From: [Butler, Steve](#)
To: [Hackenbracht, Jeff](#); [Saeed, Shirwan](#)
Subject: FW: Pages from PID 117607_FRA-161-15.80 Noise Walls_Stage 2_01-22-24_Markups.pdf
Date: Thursday, March 21, 2024 11:27:24 AM
Attachments: [image001.png](#)

Please see response in [Magenta](#) below.

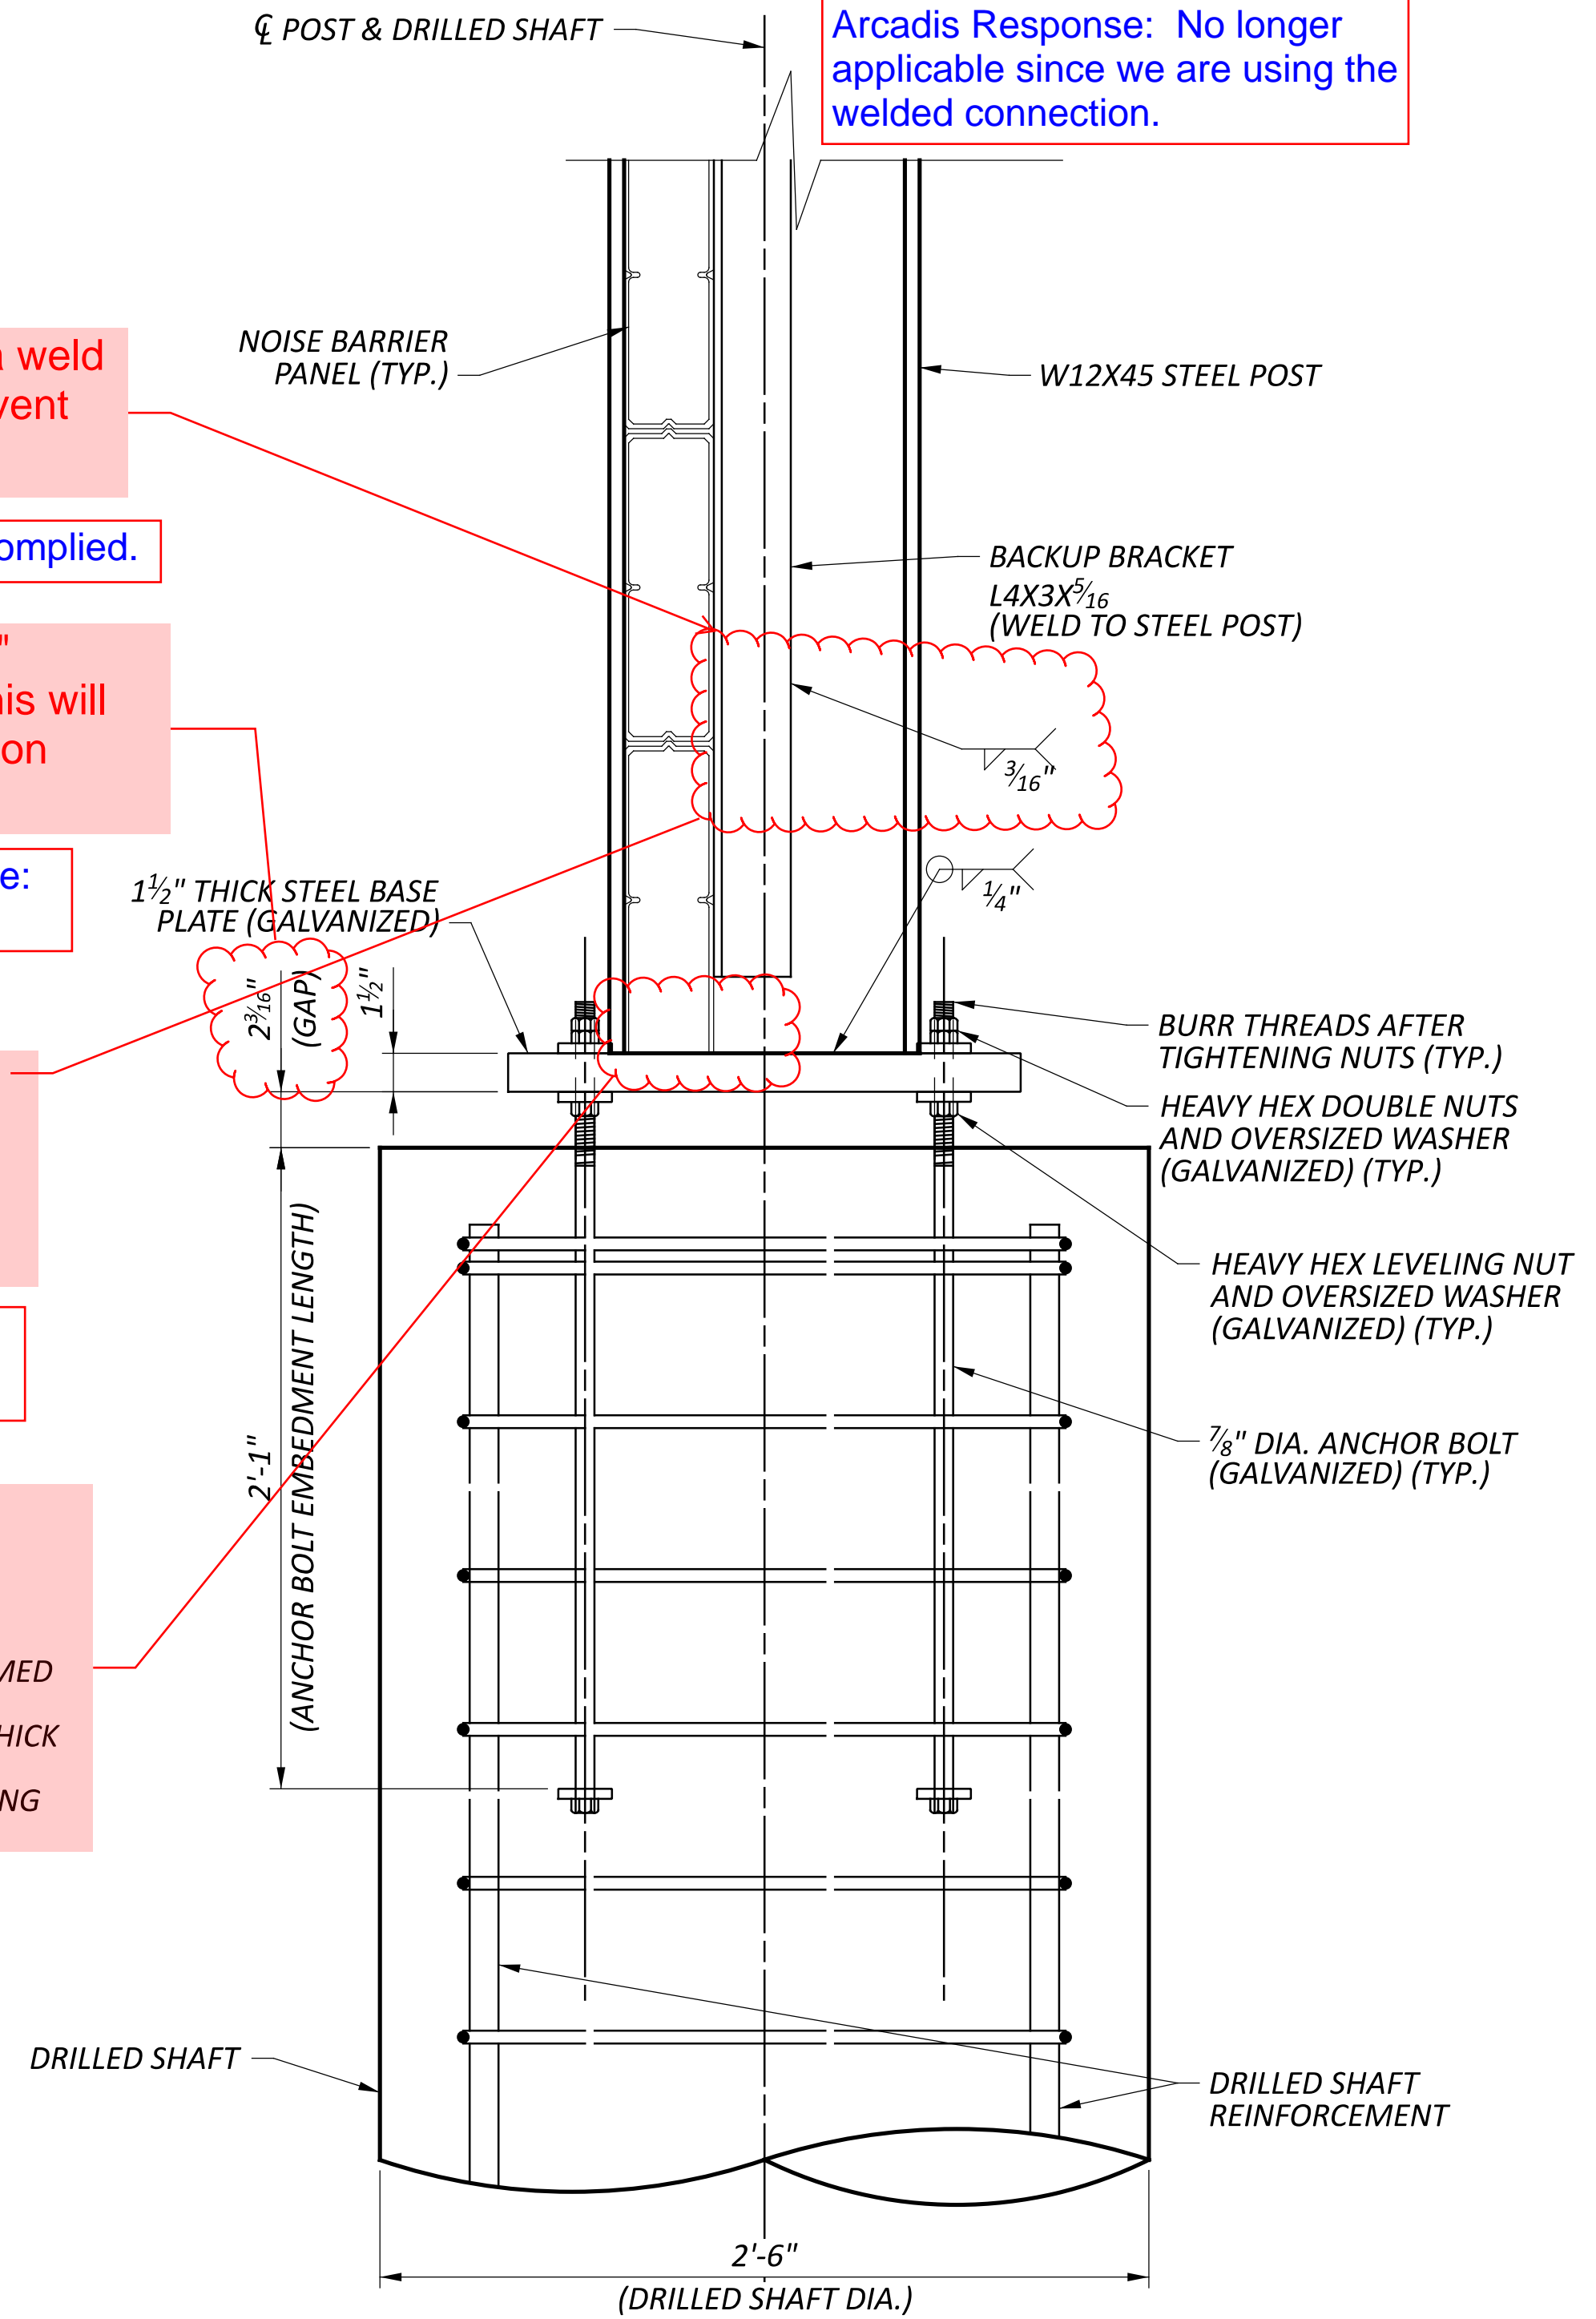
Arcadis Response: Complied.

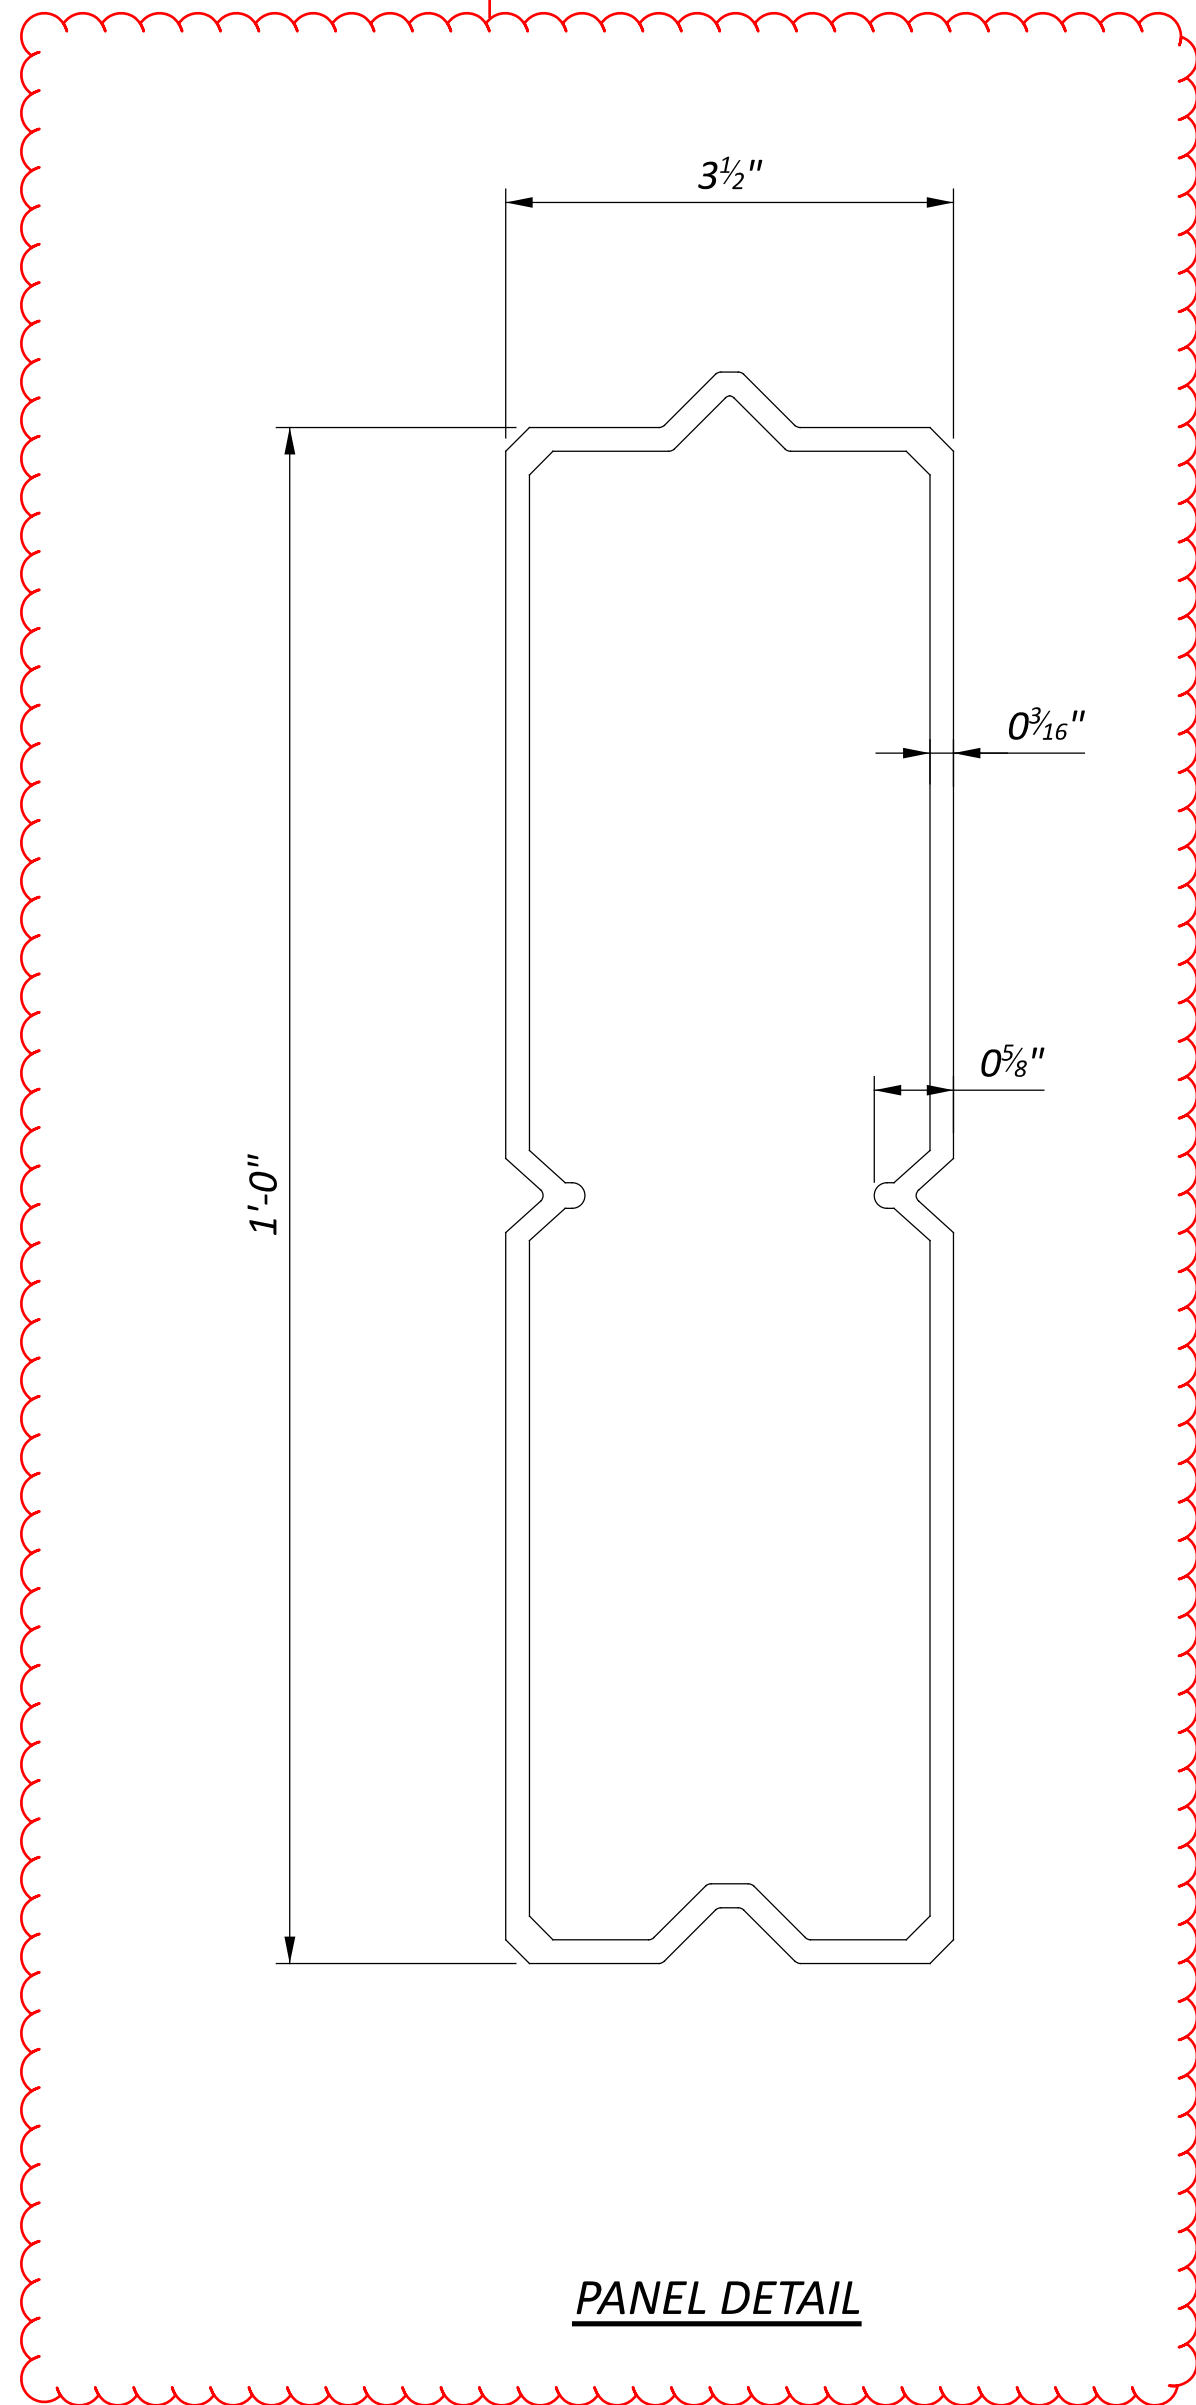
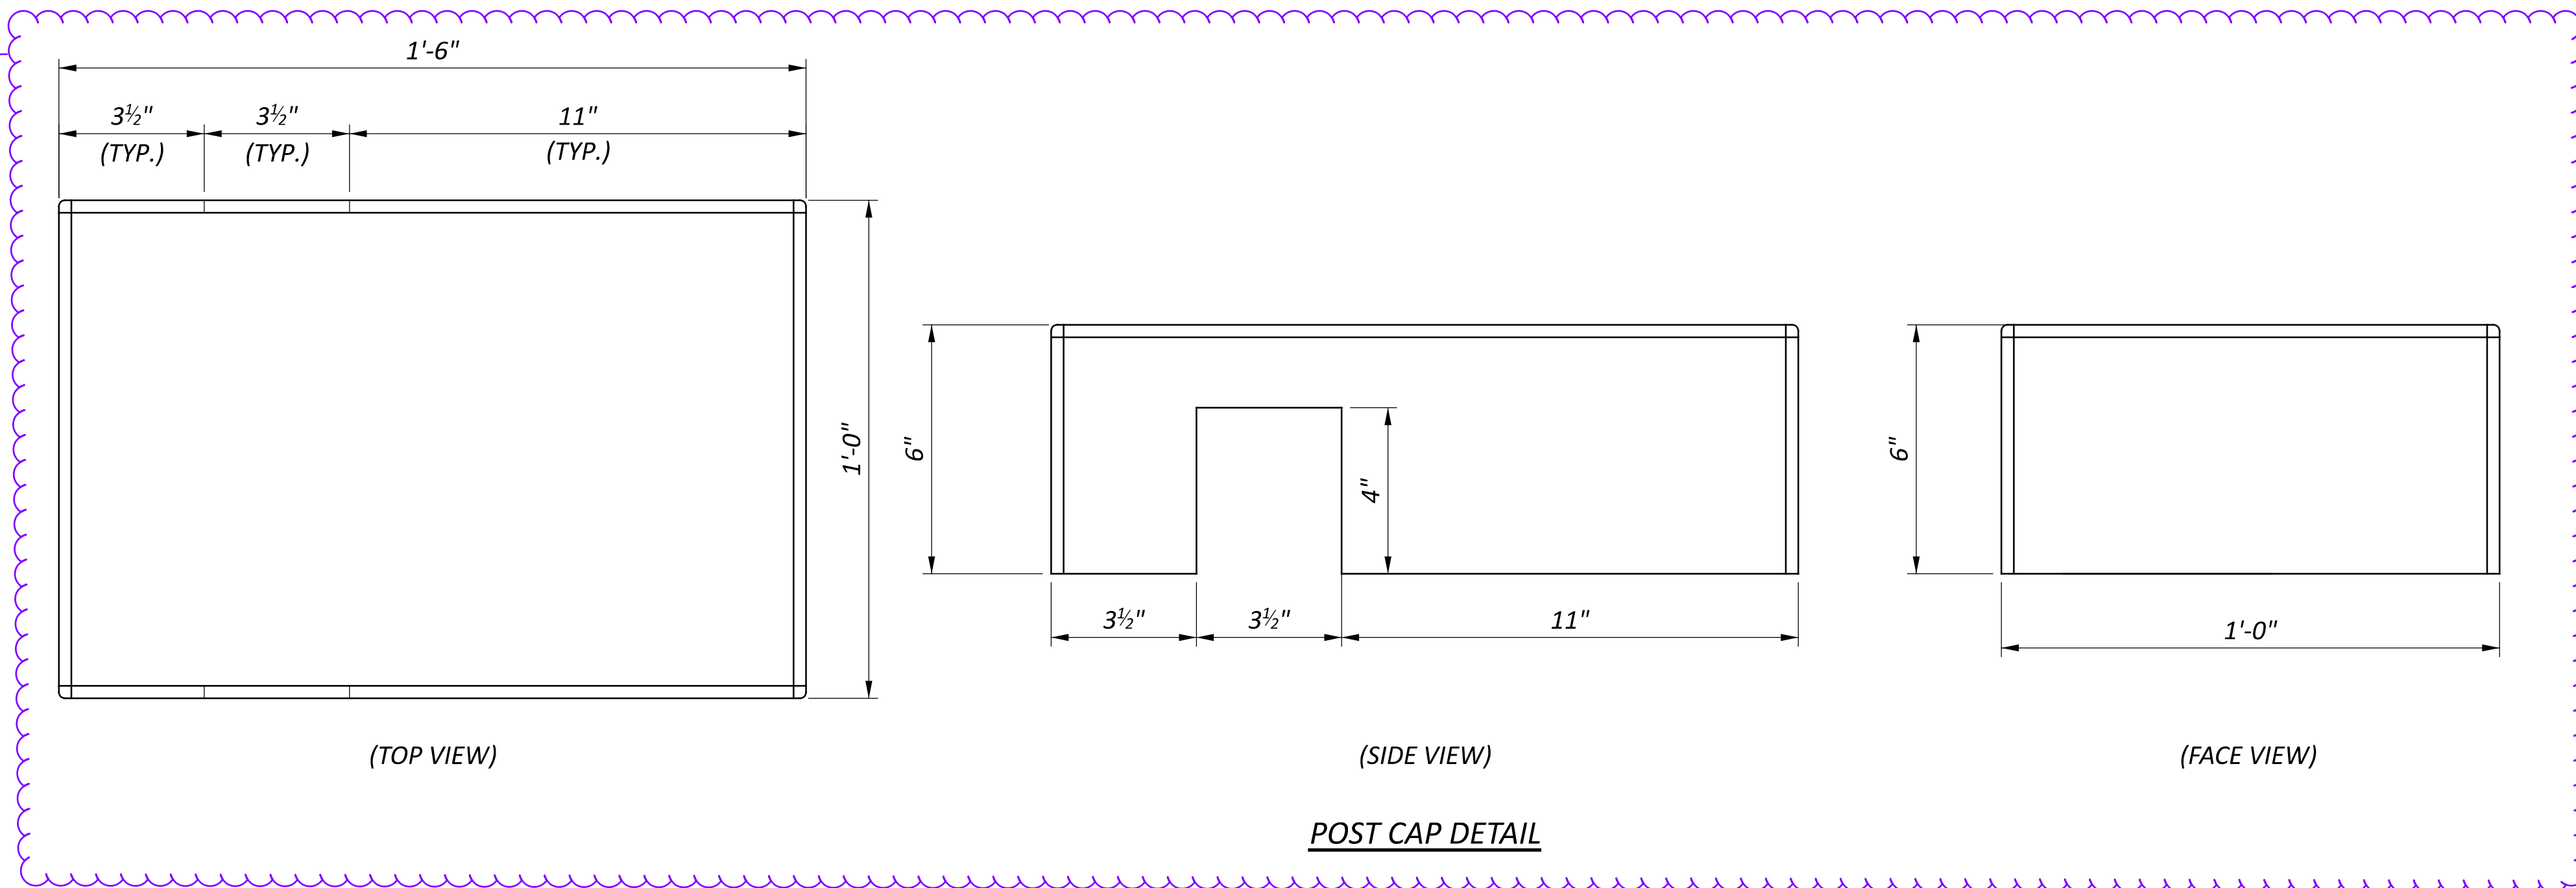
Arcadis Response: Complied. The holes in the structural steel shall be shop drilled before galvanizing, and the holes in the panels shall be field drilled to aid tight fit.
